**Serial ATA
International Organization**

**ECN067v0_SATA31_PMSignatureforSWReset_Set
DeviceBitsFISDescription_NCQQueueMgmtComm
andResponse_GSCRTypoError**

**Title: Port Multiplier Signature for Software Reset,
Description of I field of Set Device Bits FIS,
NCQ Queue Management Subcommand response,
Typo Error in GSCR Reference**

Proposed correction to Serial ATA Revision 3.1

Figure 235 – NCQ QUEUE MANAGEMENT, Abort NCQ Queue - Successful completion

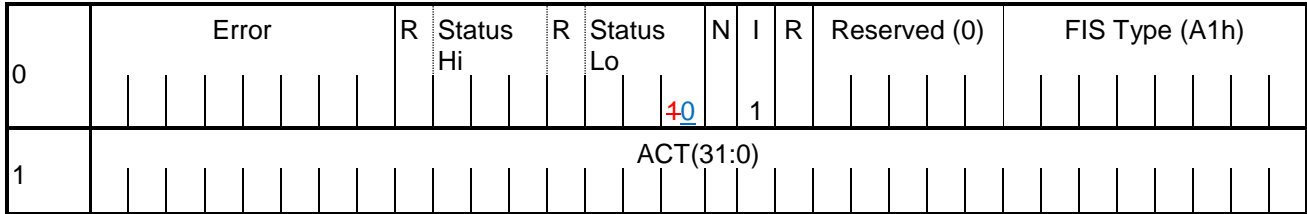
There is a contradiction between the value of Status Field shown in the Figure 235 and its description. Similar issue is with the Figure 239 and the description of its fields. The conflicting regions are highlighted in the snippets below:

The content of the Status field shown in the Figures is in conflict with the description of the field. The description of the field recommends the value of '0', while the figure demonstrates the value as '1'.
